Final PRE-APPLICATION CONFERENCE
Lockwood Meadows Subdivision Lots 13,14,16,24,26,27,31,34,35, & 64
Attached ADU's
2024-013 PAC

Site Address	2316 Badger Way & 2311 Juniper Circle Bk 312 P 298
Legal Description	Lockwood Meadows Subdivision located in the W ½ of the ¼ of Section 2, Township 4 North, Range 1, East of the Willamette Meridian
Applicant	Tyson Grey Cedar Ridge Homes 503.666.4240 tyson@cedarridgehomes.us 21632 SE Stark St. Gresham, OR 97030
Applicant's Representative	Same as applicant
Property Owner	David Grey 503.666.4240 tyson@cedarridgehomes.us
Proposal	The applicant is requesting to add 893 square foot attached Accessory Dwelling Units (ADU's) to ten (10) lots (13, 14, 16, 24, 26, 27, 31, 34, 35 & 64) located in approved Lockwood Meadows Subdivision. The request includes building the ADU(s) concurrently with the new single-family residential dwellings located on lots that are 7,500 square feet in size or larger. The lots are located in the LDR-7.5 zone district.
Date Issues	July 3, 2024

Site Plan

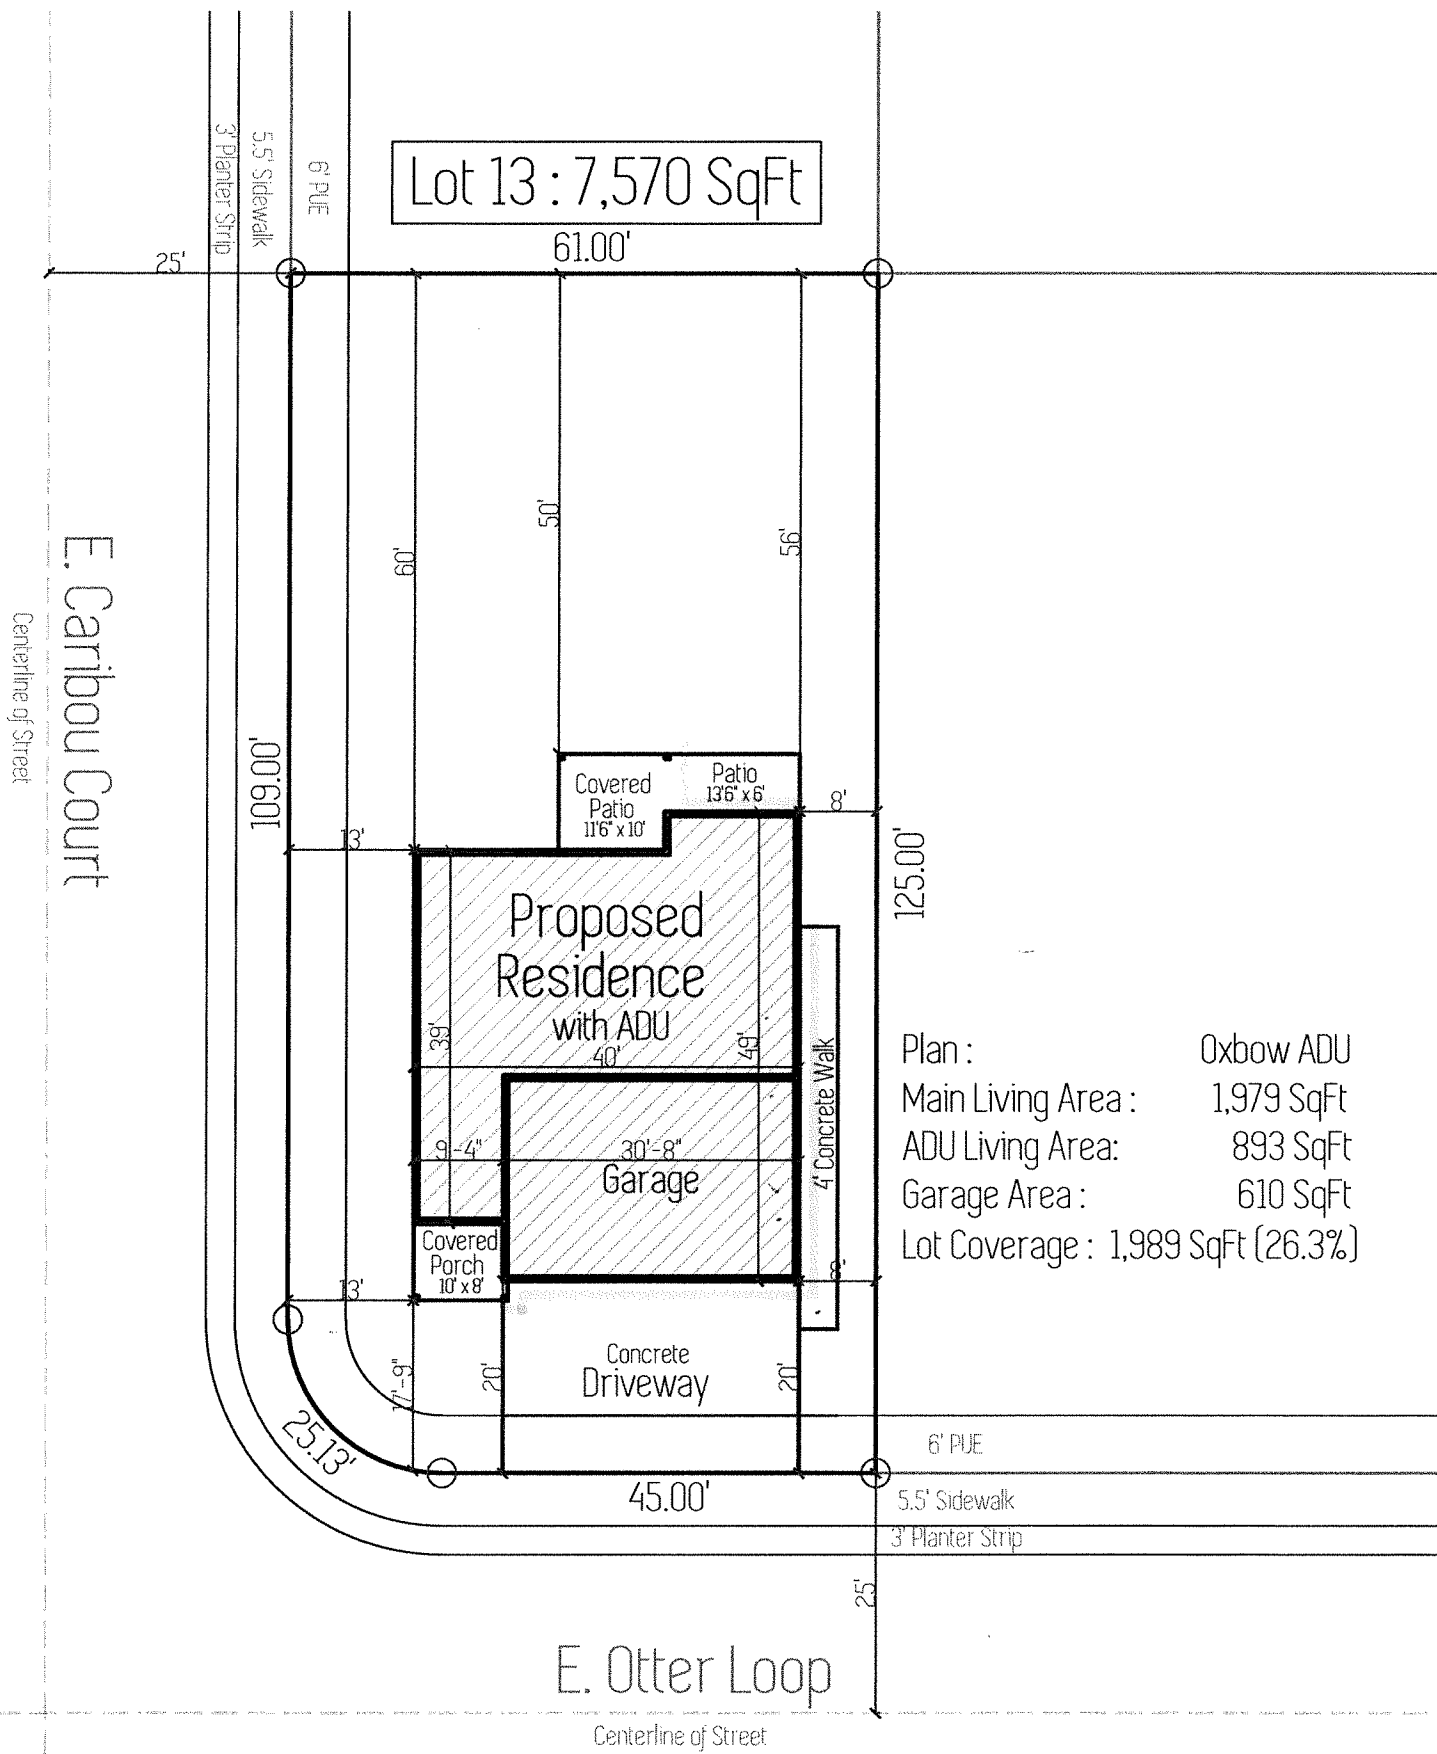
- e. ADU's shall adhere to the front setbacks of the underlying zone and shall not be closer to the front lot line than the single-family dwelling. *[The drawings provided for the proposed ADU's show the ADU's will adhere to the 20-foot front yard setbacks]*

- f. Consistent with Table 18.130.080, Footnote 3, ADU's require a setback of 10 feet from street side lot lines, five feet from interior side and rear yard lot lines, and six feet from the single-family dwellings. *[All proposed ADU's shall meet the ADU setback requirements]*

- i. One off-street parking space is required for ADUs in addition to the parking required for the single-family dwelling. The parking requirement can be met by existing parking on site. If insufficient off-street parking exists on site to meet the single-family requirement plus the one additional space for the ADU, then additional off-street parking shall be provided. *[The proposed single-family homes have a three (3) car garage with a 30' driveway. [The proposed ADU's will meet the on-site parking]*

- k. Additional access may be provided to an ADU if it meets city driveway standards. *[The proposed plans show an access for the ADU's located on the interior side yard of the residence]*

Elevations

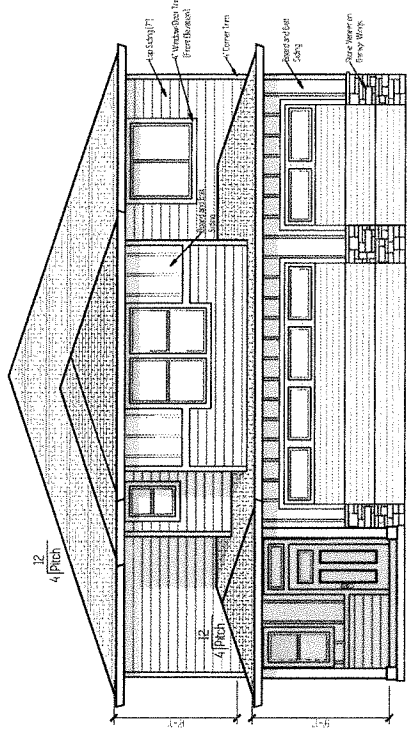
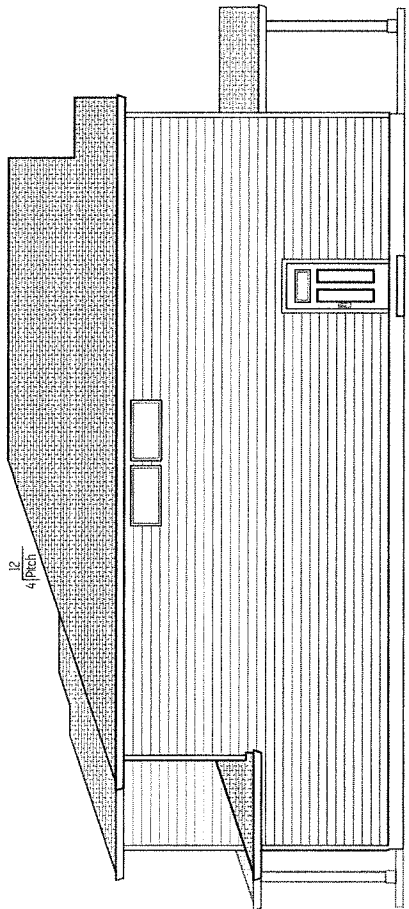
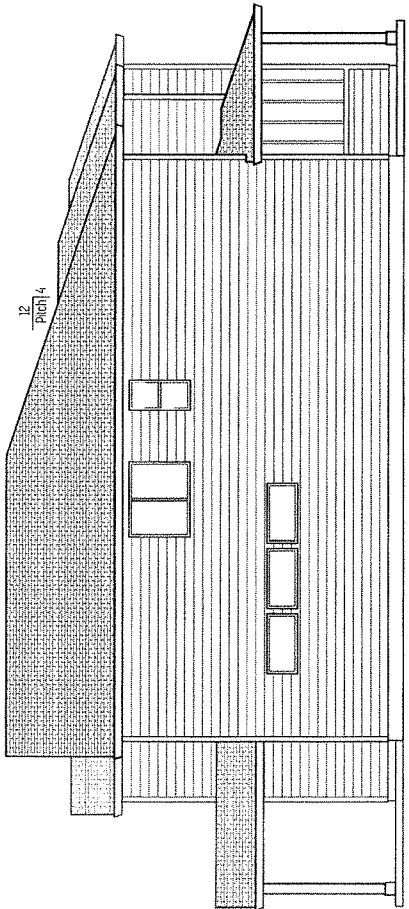
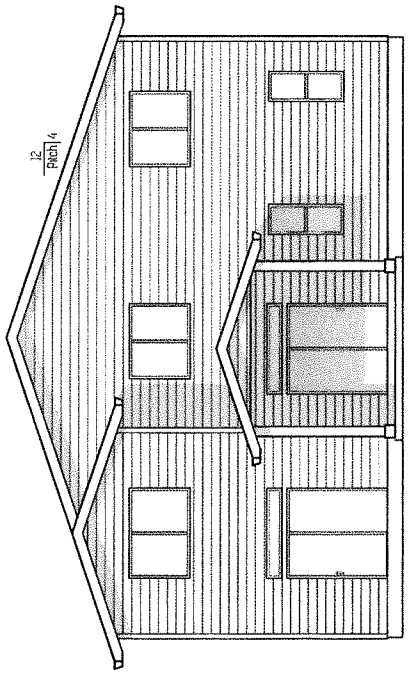
- h. The exterior appearance of an addition or detached ADU shall match the single-family dwelling's siding, color, and roof form and pitch. *[The plans submitted show the proposed ADU's to match the proposed single-family residence. All proposed ADU's shall match the appearance of the single-family residence]*
